**Proposed Residential Development**

**320 McCowan Road**

### **Derailment Protection Report**

**Jablonsky, Ast and Partners – Crash Wall Response to Peer  
Review Comments – Letter dated June 9, 2021**

## SOUTH CRASH WALL - WALL DESIGN

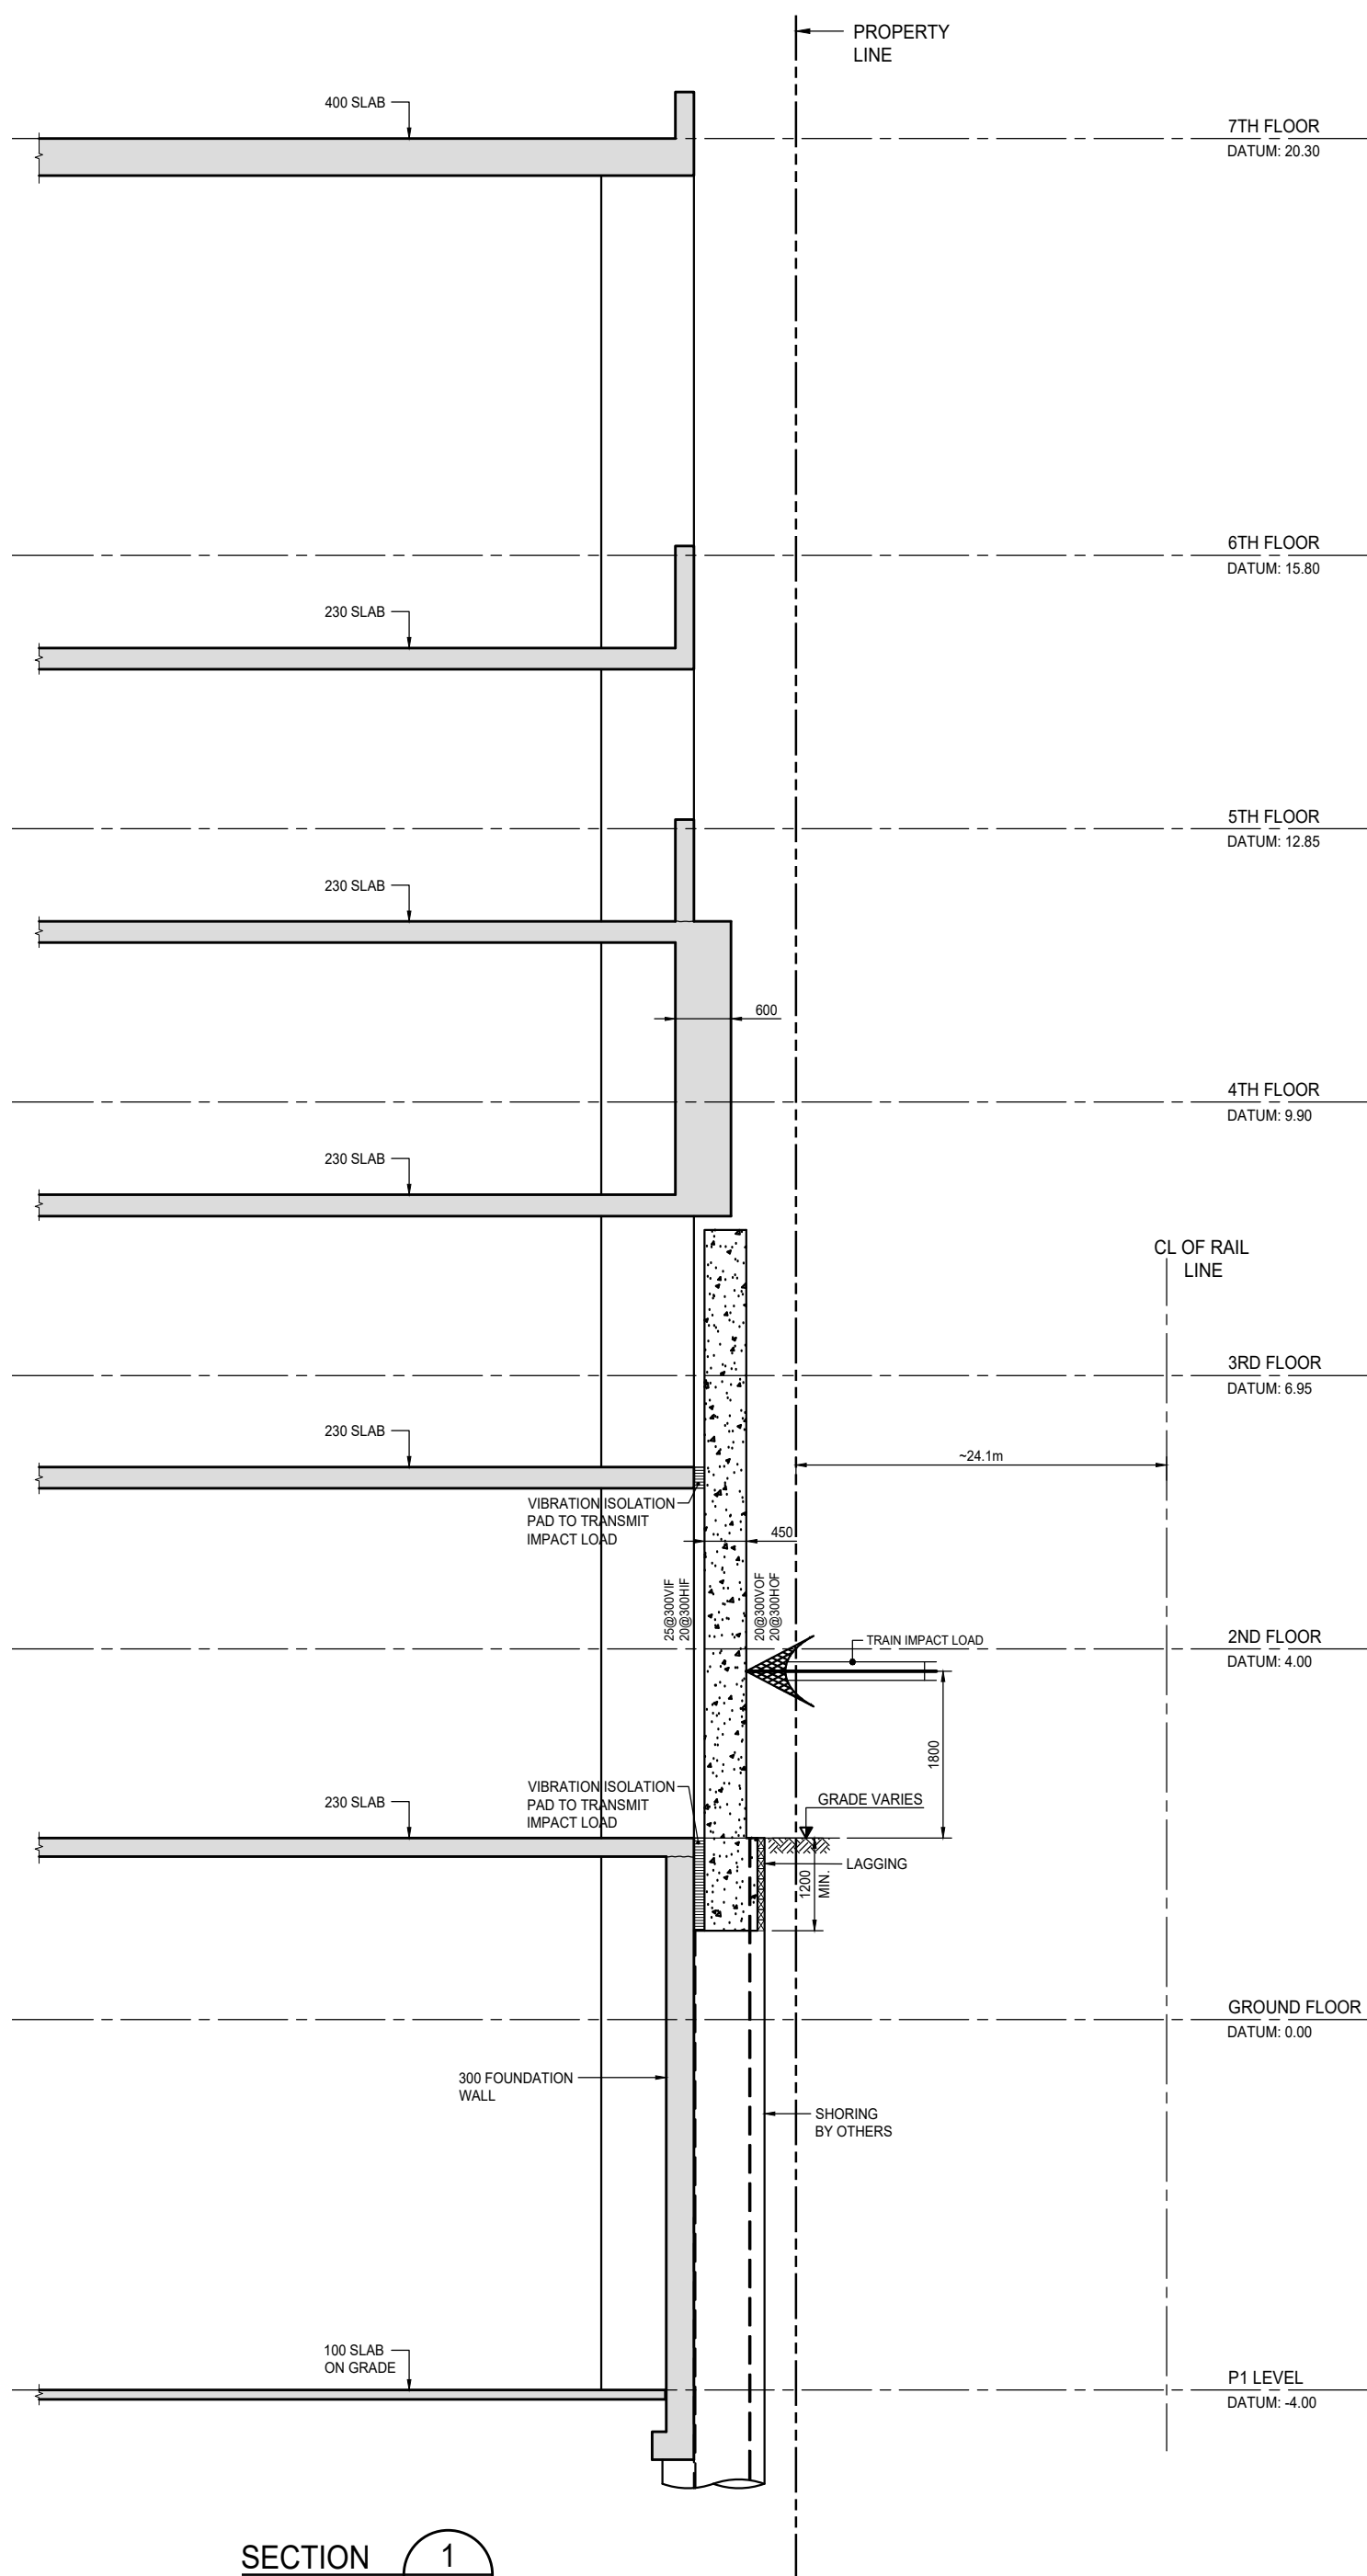
- 6. No load calculations or energy balance analysis were provided in the DPR report which is not in conformance with AECOM guidelines. It is recommended that these calculations are included in the revised DPR to describe the design criteria of the crash wall.**

- 8. The DPR proposed crash wall thickness of 0.45m is in compliance with the minimum requirements of the AECOM guidelines as the distance between the crash wall and the closest track centerline is 24.3m. However, the consultant shall provide analysis to show that the proposed crash wall thickness is sufficient to withstand the design crash loads. The structural calculations and design drawings for the crash wall shall be provided to the governing body for review during the design phase. All structural drawings and calculations shall be signed and sealed by a registered professional engineer in Ontario.**

Please see attached calculations for the crash wall in accordance with the AECOM guidelines.

Please see attached calculations for the crash wall load capacity base on the above-mentioned loads. Also see attached updated structural section with reinforcement indicated.

x	1.01	m	minimum distance from support to point of impact
h	3.90	m	height between supports
$F_{MAX}$	207	kN/m	maximum force per metre length of wall
$t_{WALL}$	450	mm	thickness of wall
$M_f$	155	kN.m	applied moment
$V_f$	154	kN	applied shear
